### Objection

Objector:	Mr Richard Carey
Organisation Name:	Glenveagh
Objector Address:	Digital Office Centre, Block B, Maynooth Business Campus, Maynooth, Co. Kildare.
Objection Title:	Objection #OS010431 - Applicant objection for Reg No:[W0301-01]
Objection Reference No.:	OS010431
Objection Received:	12 July 2022
Objector Type:	Applicant
Oral Hearing Requested?	No

# EPA PROPOSED DECISION REVIEW

## Bay Lane Soil Recovery Facility

**Figure 2.1: Water management features and sampling locations**

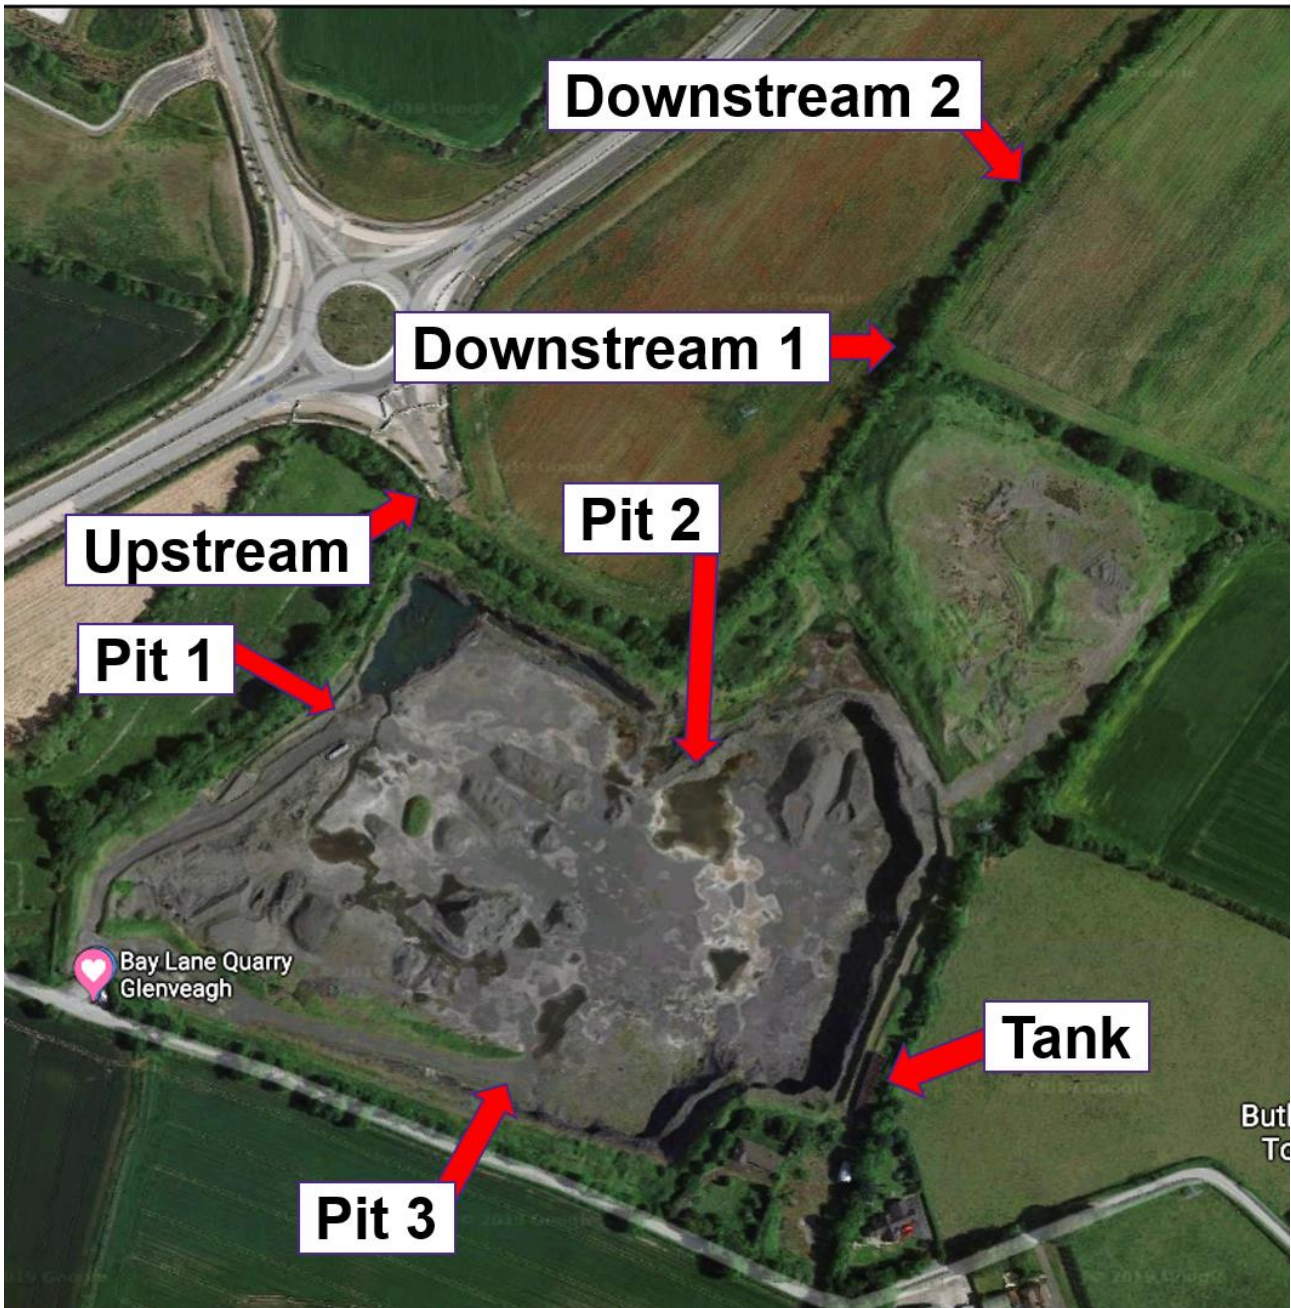
The locations of these sampling points are indicated in **Figure 2.1**. These locations are termed:

1. “Upstream” – upstream of the discharge point, on the NW side of the roundabout, approximately 200 metres NNW from nearest point of Bay Lane Quarry property boundary.
2. “Downstream 1” - at the proposed discharge point, and “Downstream 2” – 100m downstream of the discharge point.
3. “Pit 1”, “Pit 2” and “Pit 3” are access points on ramps down to the pit as indicated.
4. “Tank” Settlement tank.

During periods of low water levels, samples are taken from Pit 1, Pit 2 and Pit 3. During periods of low water levels, samples are taken near “Pit 1”.

This body of water was confined to the North-west corner of the site when the aerial image in **Figure 2.1** was taken, and this is representative of surface water conditions at the time of writing in July 2022.
